MELISSA

TECHNICAL NOTE 83.7

Expertise of level 0 control loops on the 100 L pilot reactor

Prepared by/Préparé par	Jean-Luc Estival, Olivier Gerbi
Reference/Référence	ESA/ESTEC contract 19304/05/NL/CP
Issue/Edition	1
Revision/Révision	1
Date of issue/Date d'édition	March 07
Status/Statut	Draft

Figure 7: response of pH reactor to a set point change

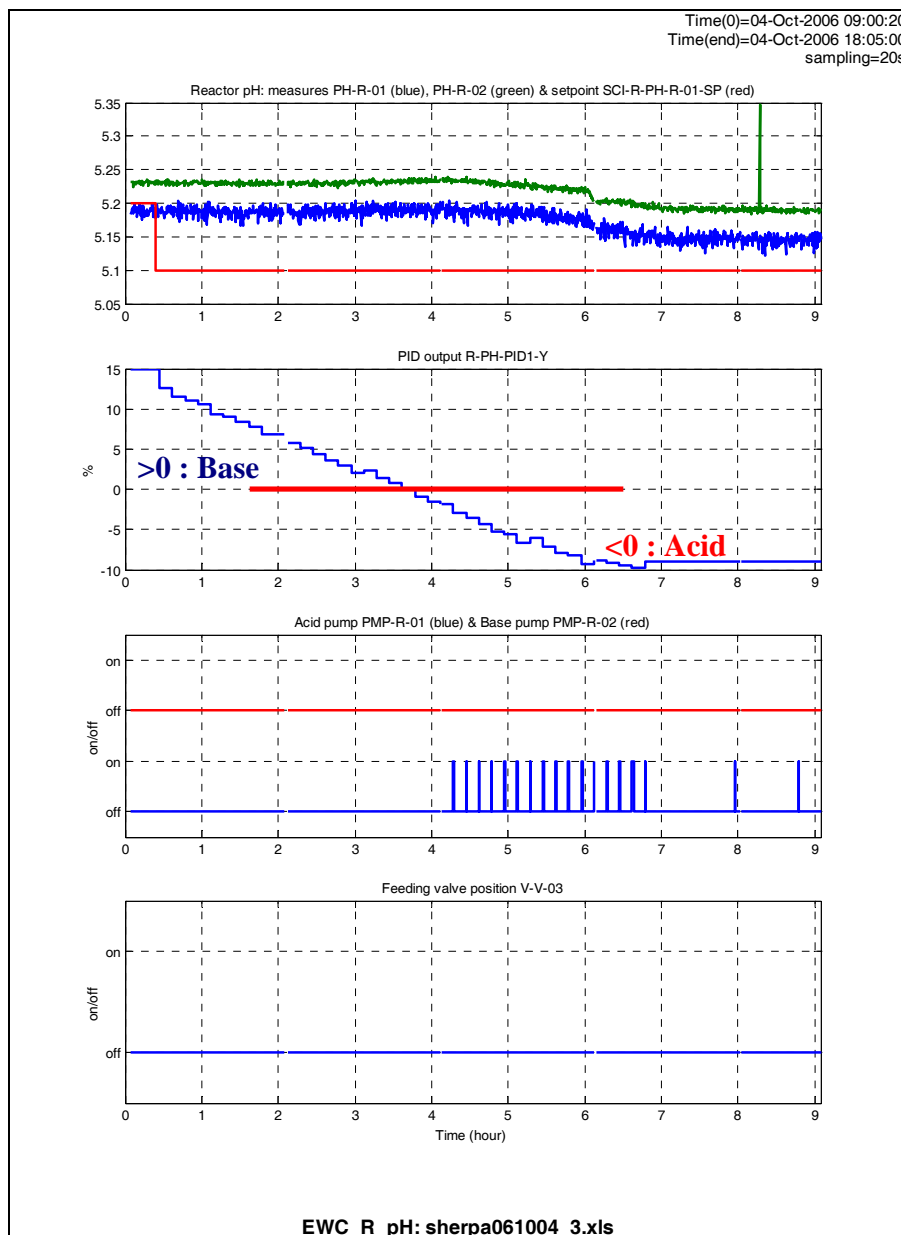
p 26, Section 3.4.1	<p>According to the explanation, an integration time is necessary before action is taken on pH. In total, the time to reach the new pH set point is the sum of this integration time and of the active time (being estimated as 3 hours). According to figure 7, no less than 6 hours in total are needed to reach the new setpoint. Does this mean the integration time is 3 hours? Can this integration time be minimised?</p>	<p>This integration time could be minimised, by adding other blocks in the control. But two comments have to be made: * it is better to wait a certain time before switching from one reagent to the other one. The integration time gives that kind of delay. * the pH variation here is rather slow. In case of a larger PH error, the integration time will be smaller.</p>
p27, section 3.4.2	<p>According to figure 8, a disturbance of similar amplitude as the setpoint modification in section 3.4.1 is performed by feeding influent. In this case, the pH returns to its nominal value within 3.5 hours, which somehow corresponds to the response time mentioned in previous section. Could you please explain the different behaviour of the pH control system for different perturbations which are of similar amplitude (i.e. no time needed for integration in this case)?</p>	<p>In that case, the integration time is 0 because at the beginning of the test the initial value of the PI controller is 0. Remember that this value results from past pH deviations from its set point.</p>

Figure 8: response of pH reactor to disturbances

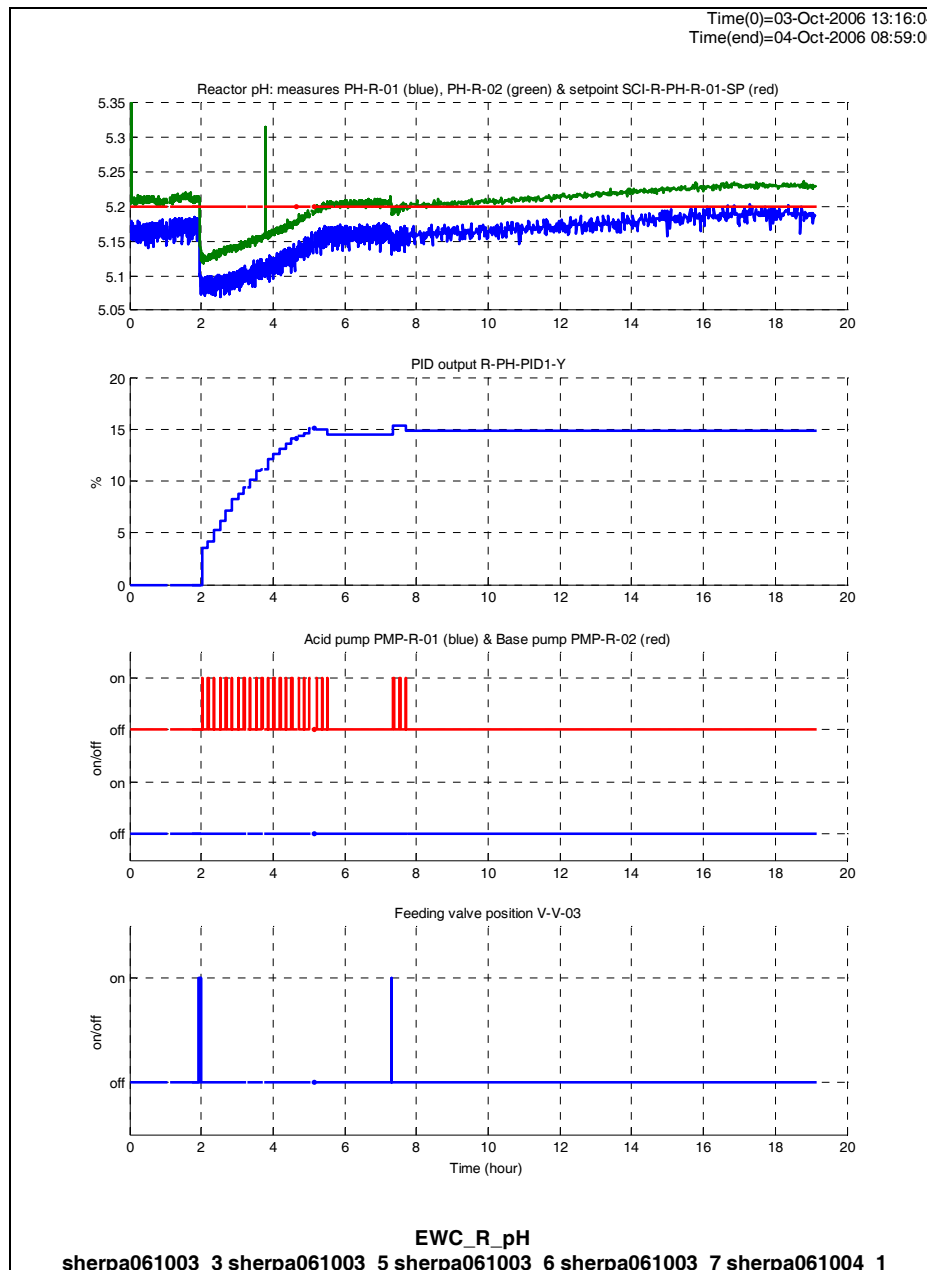
p28, section
3.4.2

The time needed to recover after pH changes seems to be rather long. In case pH disturbance ± 0.1 pH are caused by compartment feeding, the time currently needed to recover nominal pH may be too long to ensure nominal conditions in the bioreactor (i.e. pH SP = 5.2, Feed every 3 hours causing 0.1 pH decrease anytime. Will C1 ever run at pH = 5.2?). Could you please provide us with your opinion on this point?

The variation of pH (-0.1) results of a 5 L feeding of the reactor, following a 5 L draining (see Figure 5 in section 3.3). This is a rather big disturbance. The normal feeding volume is much smaller, so is the pH variation related to feeding. See for instance the 2nd feeding at time 7.5 hour on figure 8 (p 27 section 3.4.2). The pH variation due to this "normal" feeding is less than -0.02 . According to the pH requirements defined by EPAS, the pH should remain between 5.1 and 5.4. The current pH control strategy enables to have the pH in this range, for normal feeding disturbance.
